GE Nuclear Energy

MFN No. 167-93
Docket STN 52-004

Subject: **NRC Requests for Additional Information (RAIs) on the Simplified
Boiling Water Reactor (SBWR) Design**

The reference requested additional information on the SBWR Design. In partial fulfillment of this request, GE is submitting responses to RAIs 950.1 - 950.16 and RAIs 950.21 - 950.26.

Resp. to RAI 95a.03,
Part I, App. 1A

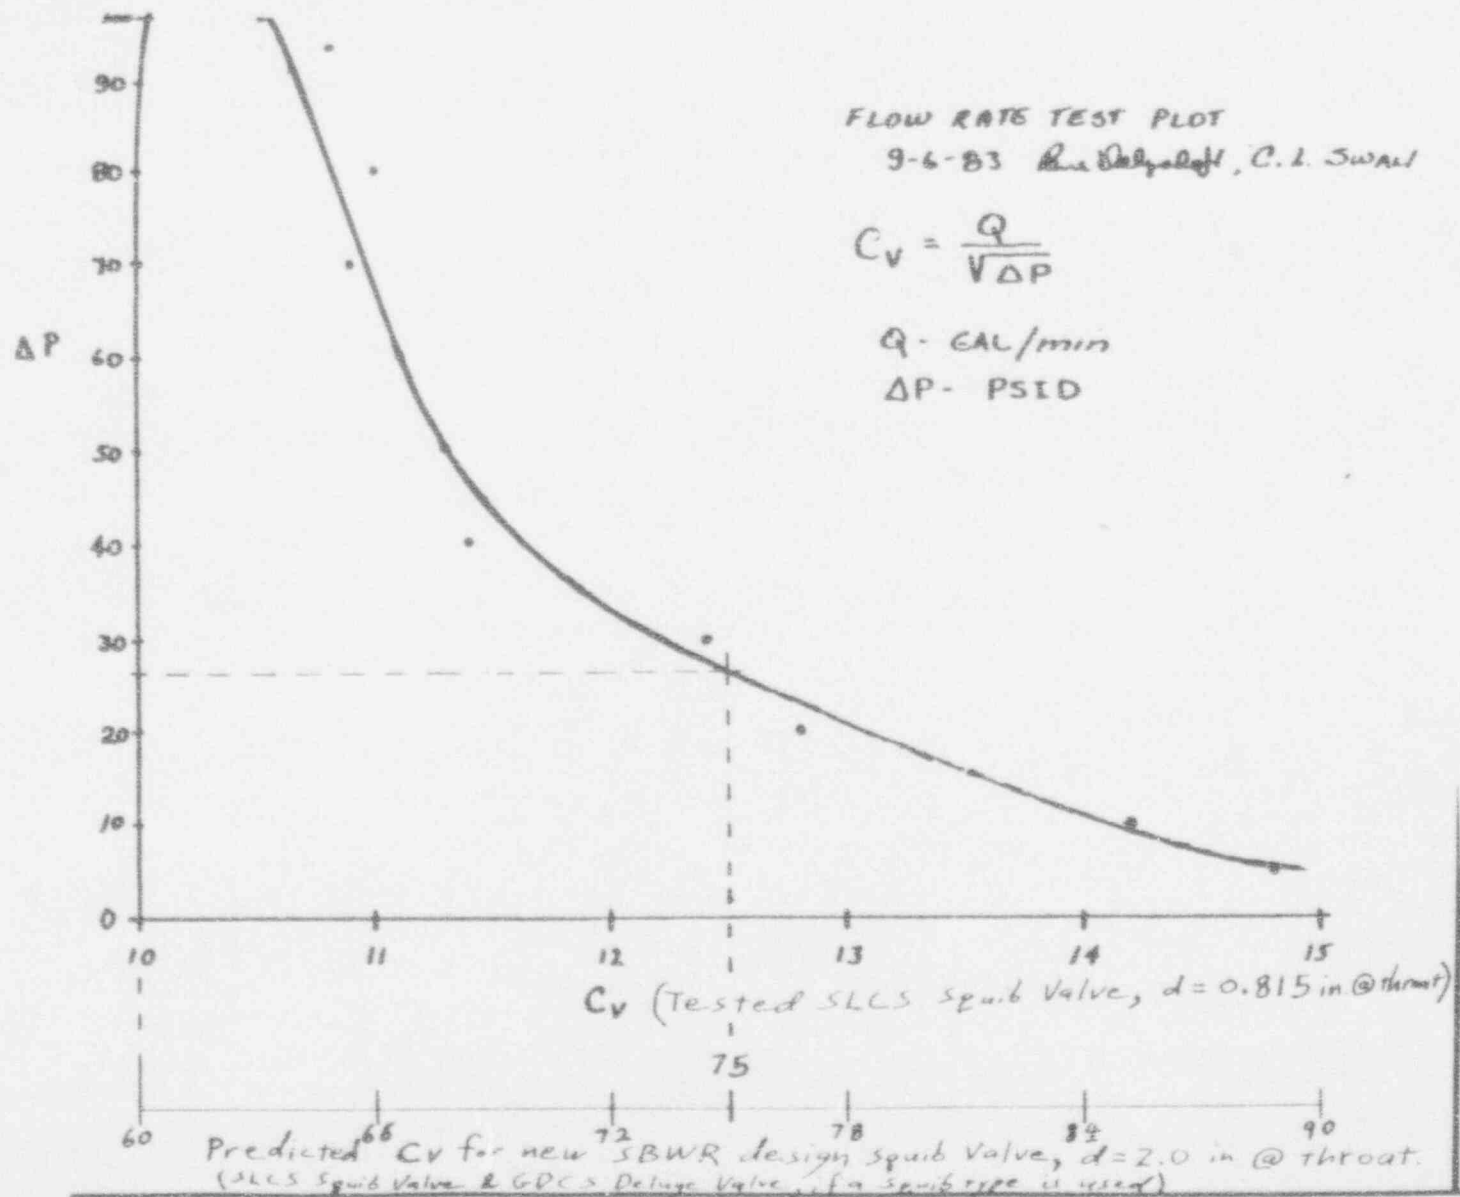
What are the pressure losses and the area associated with the squib valves?

A smaller squib valve model with similar internal geometry (proportionally smaller throat, ram, and capture space for the sheared cap) is used in existing domestic GE BWRs. Actual testing was performed on that smaller model to establish C_v for pressures of ΔP up to 100 psid. That valve model had a nominal 1 1/2-inch inlet/outlet and a throat diameter of 0.815 inch ($A=0.5217 \text{ in}^2$) at the shear section. Test results revealed that the value of C_v for this (smaller) valve model varied with the value of ΔP , and suggested a relatively smooth curve from almost 15 at ΔP near zero to about 10.6 at 100 psi.

At pressures above 100 psi, theory predicts that C_v should asymptotically approach a minimum value. The shape of the curve suggests a value of about 10 for the tested valve.

Theory further predicts, for similar geometries, that C_v is proportional to throat area; hence, the current SBWR squib valve design would expect to provide a C_v of 6.022 times (or conservatively, about six times) the C_v of the tested valve.

The current valve design meets the specification minimum C_v requirement of 40. This prediction method also estimates that the specification nominal value of 75 is exceeded for values of ΔP up to 25 psid. This is important from a practical viewpoint, as it indicates that the current design has considerable margin at low values of differential pressure, where adequate flow rate might otherwise become a concern. A graphical illustration of

the predicted C_v values (\rightarrow flow rates), superimposed over the curve for the tested (smaller) valve, is provided as Attachment 1A.

I.C. CONDENSATE DRAIN LINE

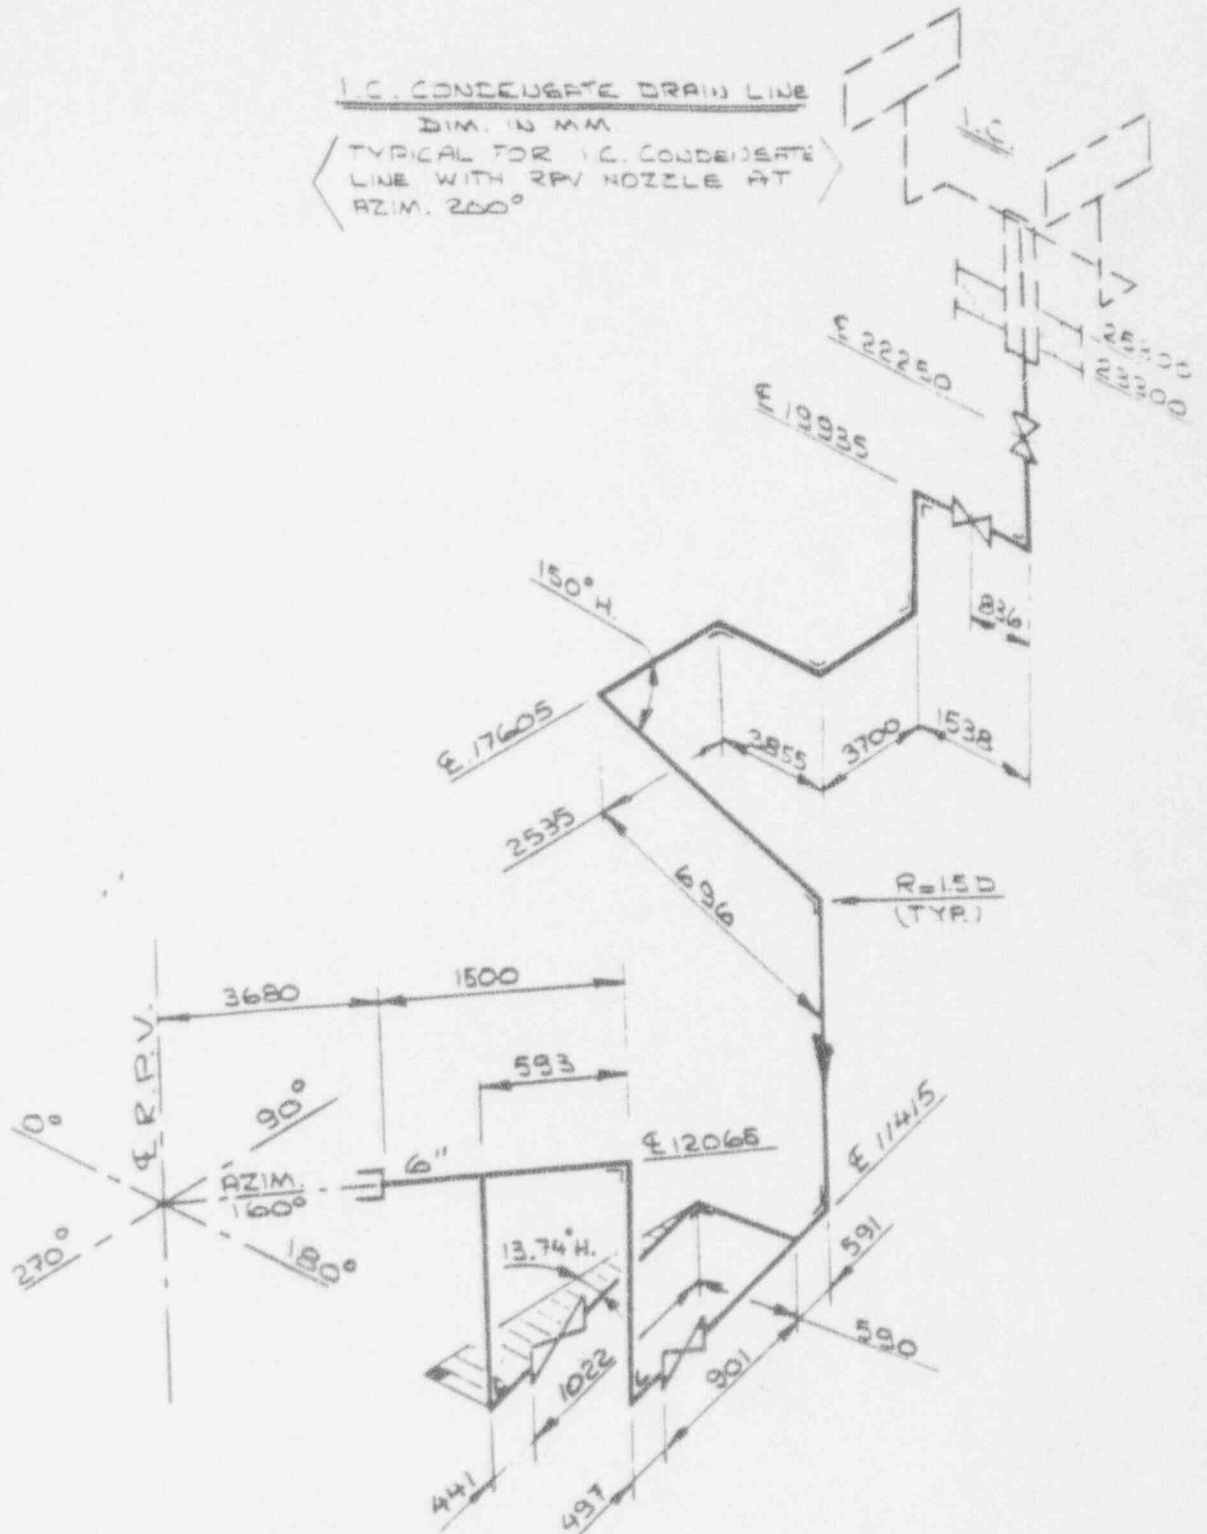
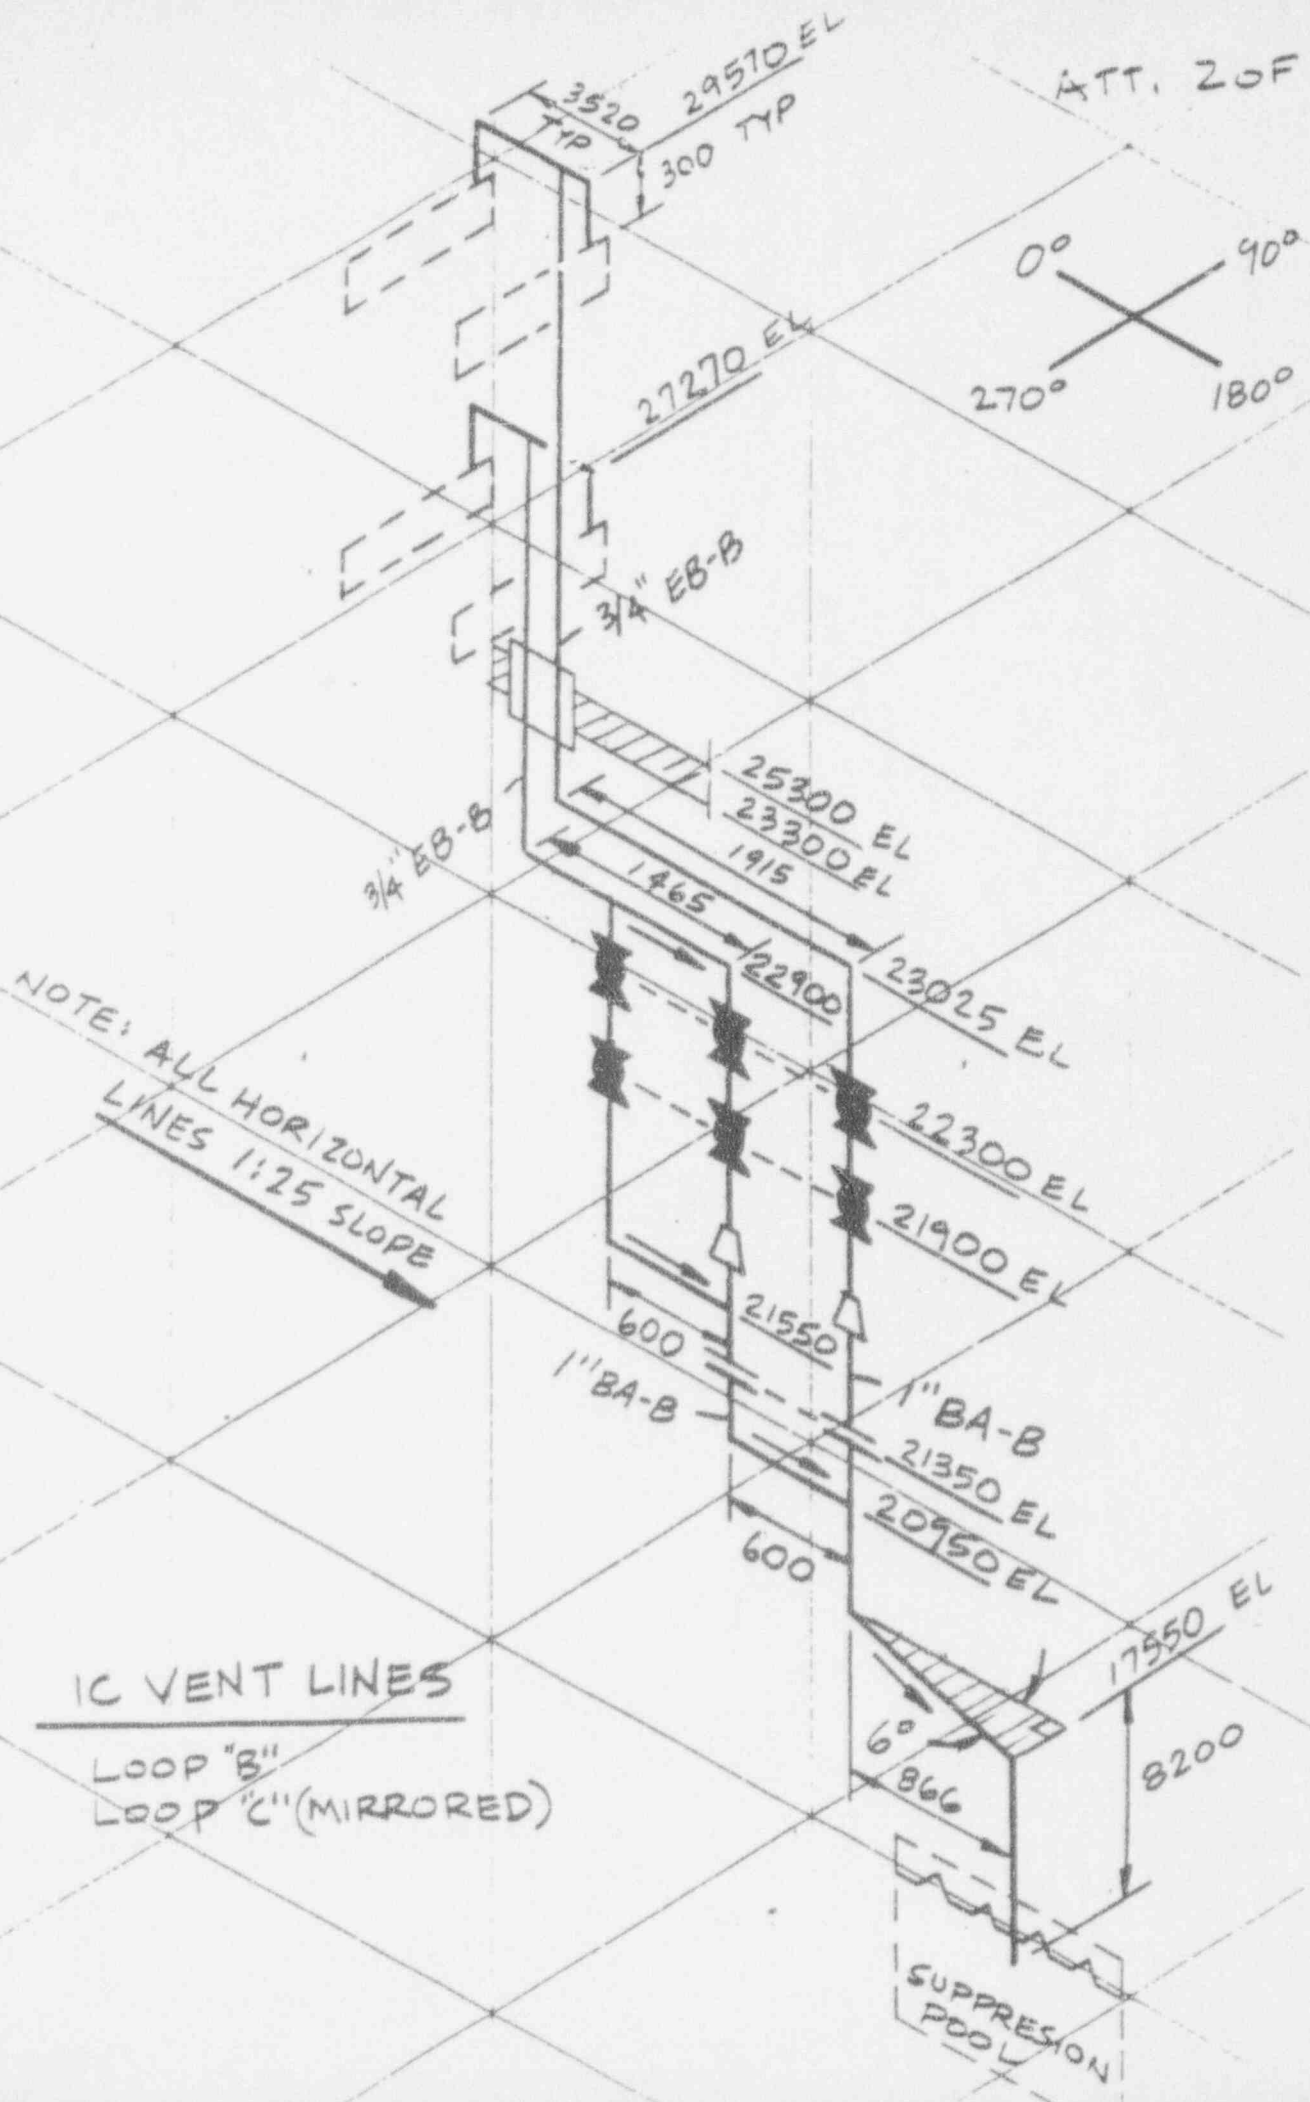
Provide a drawing showing the total pipe length and elevation difference between the isolation condenser exit and entrance to the reactor pressure vessel for the condensate return line and the non condensable vent line.

Attached is sketch 920828/4 which shows a typical drain line ("condensate return line") for (1) of the (3) isolation condenser loops. Also attached is a sketch ["IC Vent Lines (Loop B)"] that shows a typical non condensable vent line. These sketches show typical line lengths, fittings, elevations and angles.
